**Fitzroy to Gladstone Pipeline – Aldoga Reservoirs SDA Approval (AP2022/003) – Minor Amendment**

The following information has been provided to support a minor change to the Aldoga Reservoirs State Development Area (SDA) Approval.

The Aldoga Reservoirs SDA approval was received on 30 August 2022, and since this time detailed design has progressed. As a result of the detailed design there have been minor modifications to the layout and the approved plans. These modifications are depicted in Attachment 1 – Updated Plans.

DRAWN BY: OLIVER CORPUZ	08/06/23	<b>FITZROY TO GLADSTONE PIPELINE PROJECT</b> ALDOGA TANKS LAYOUT PLAN RESEVOIR AREA 1151-DL06-STN-CIV-DRG-36007
DESIGNED BY: NOURAN ABDALLA	08/06/23	
REVIEWED BY: PETER FRASER	23/06/23	
ACCEPTANCE BY: RPEQ APPROVAL

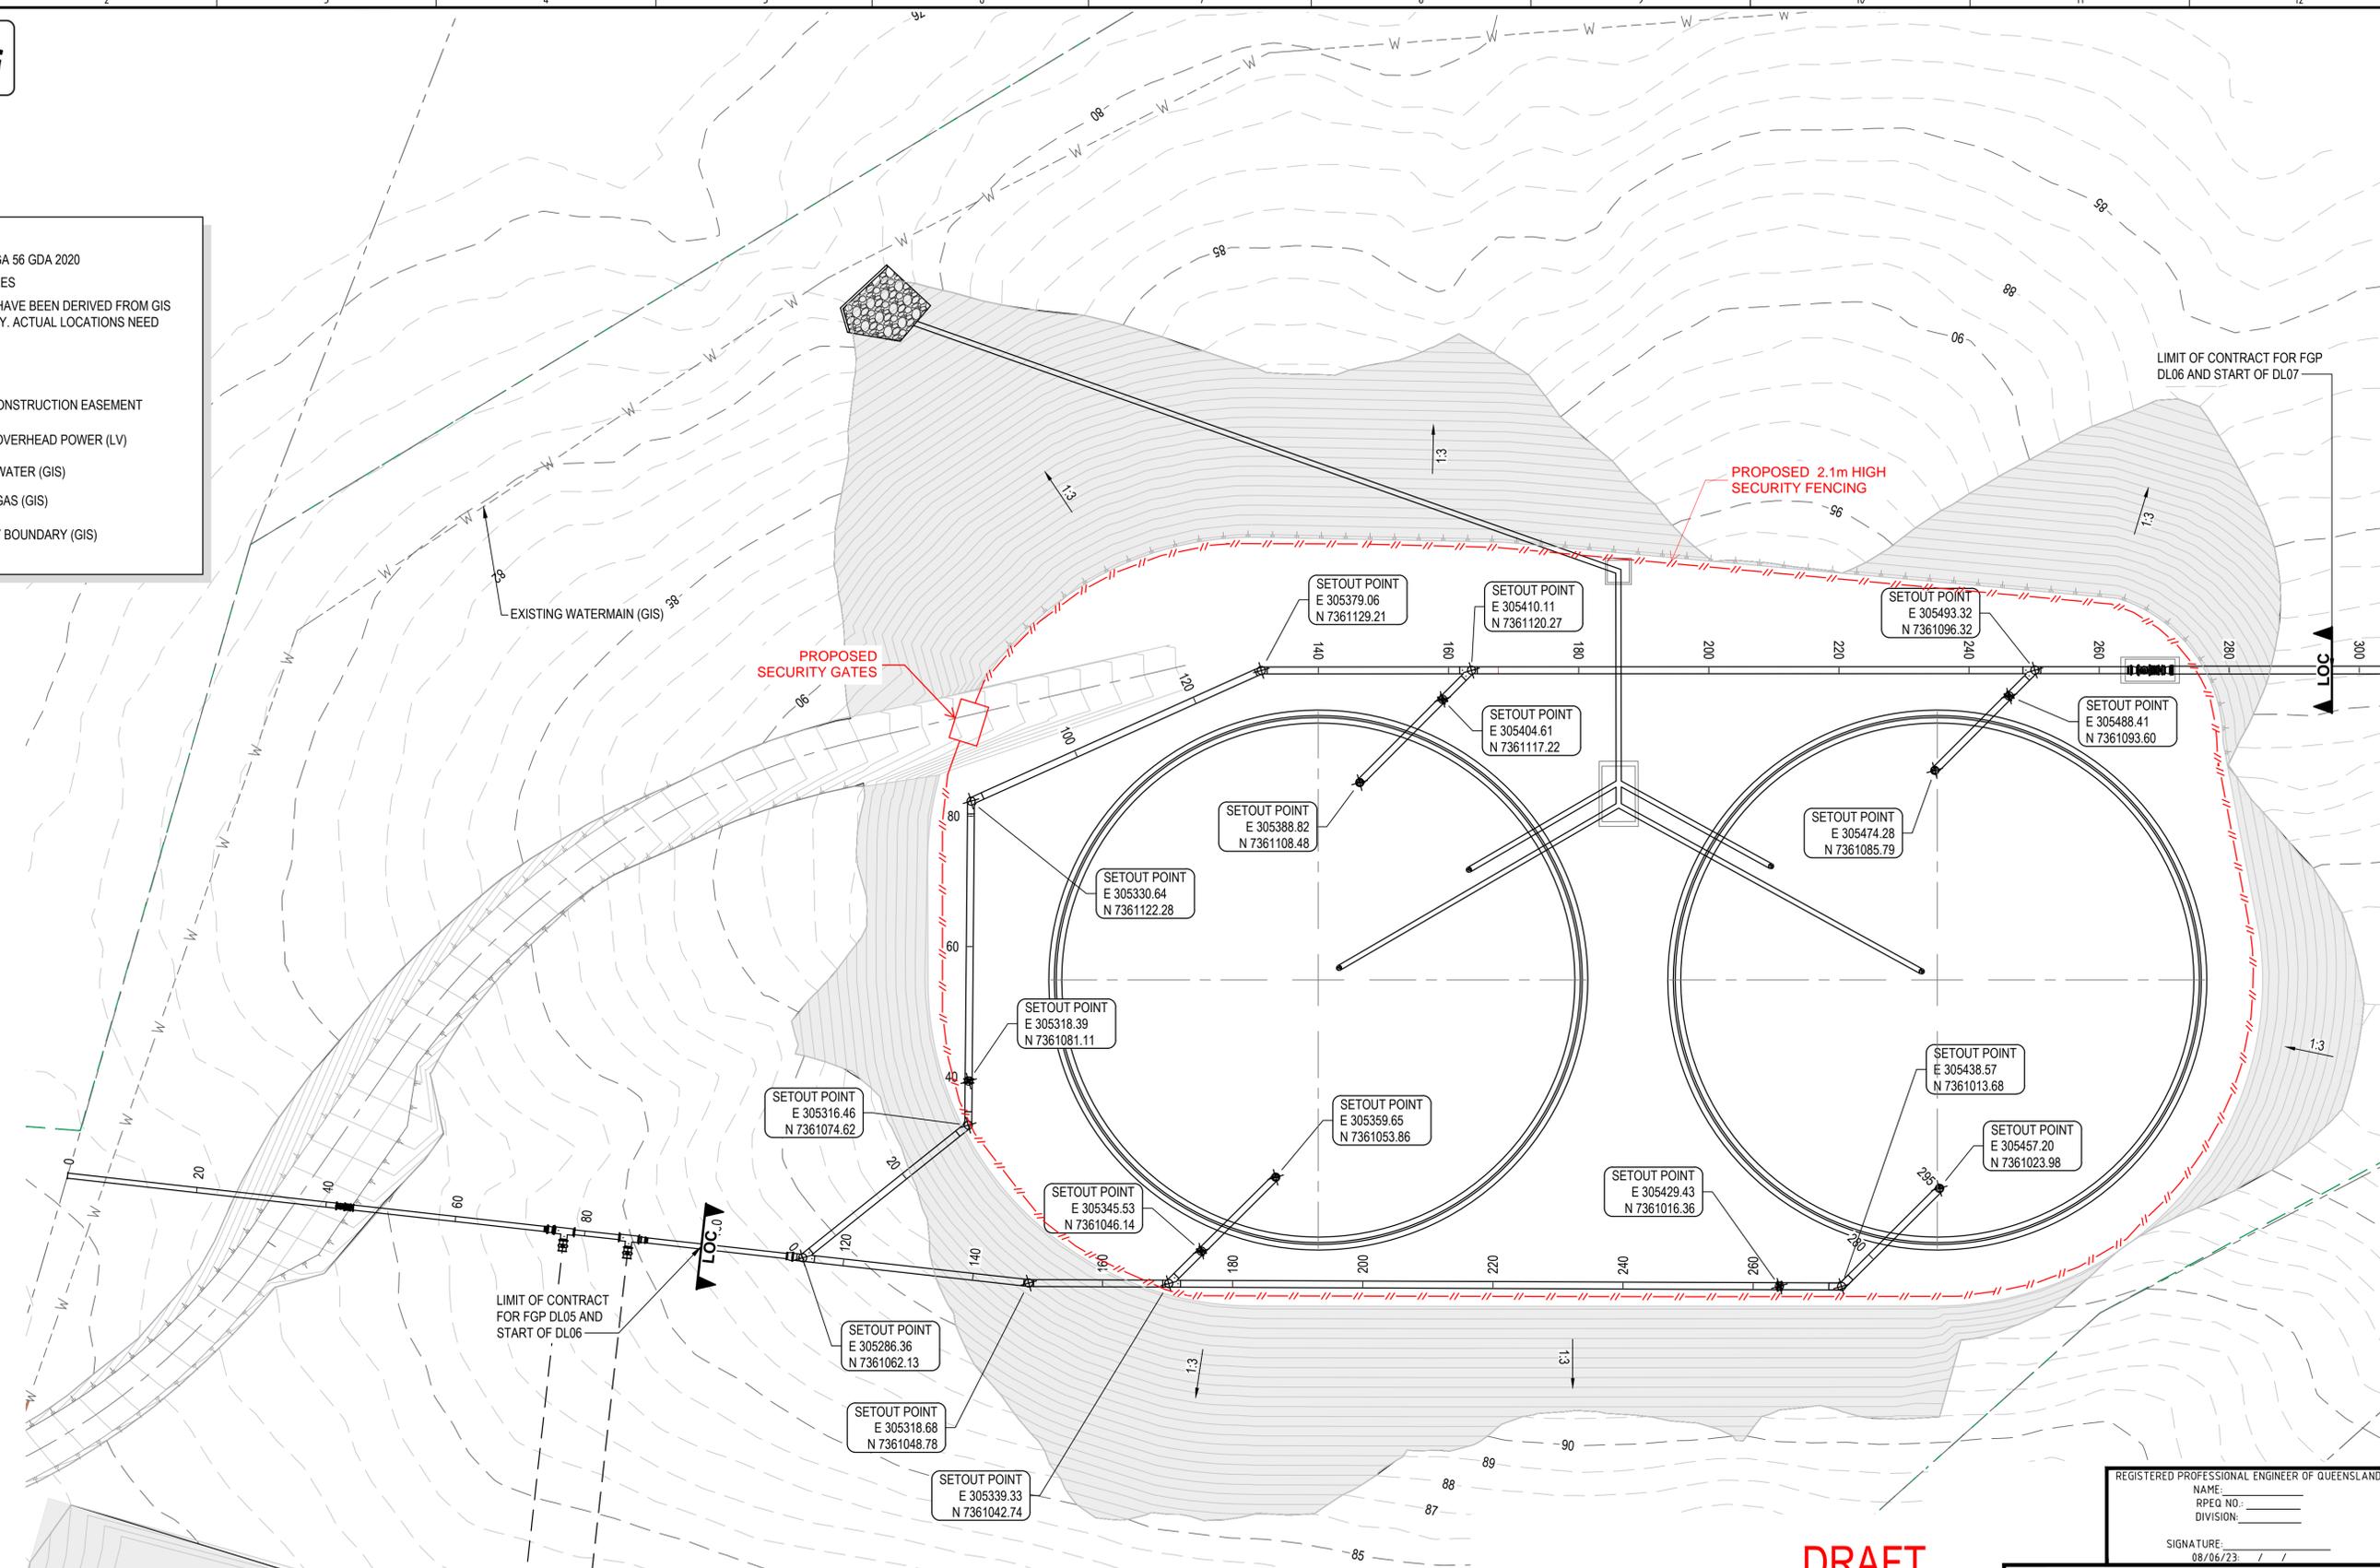
- Reservoir tanks' orientation – the concept design (as per the approved plans referenced in the current SDA approval) had the 2 x 50ML tanks partially located over cut in rock area and fill embankment, which would have caused a risk to the structures from differential settlement. The orientation change is required to fully locate the tanks on rock cut where settlement will not occur and cause cracking in tanks. There is no change in the assets / infrastructure in this GAWB-owned land, just a rotation of what was already planned and hence should be considered a minor change to the SDA Approval.

- Excavated soil is to be retained on the Site – noting the Planning Report dated 12 May 2022 referred to removal of approximately 28,000 tonnes of excavated material from the Site. The retention of this material will reduce traffic on public roads during construction and provide a foundation for a future proposed pump station on the Site by GAWB (subject to any additional approvals required). The stockpile area would be utilised during construction for a temporary laydown area, parking, and site facilities and if

- Table 1 of Condition 1.1 to be amended as per the attached plans (refer to Table 2 and Attachment 1).
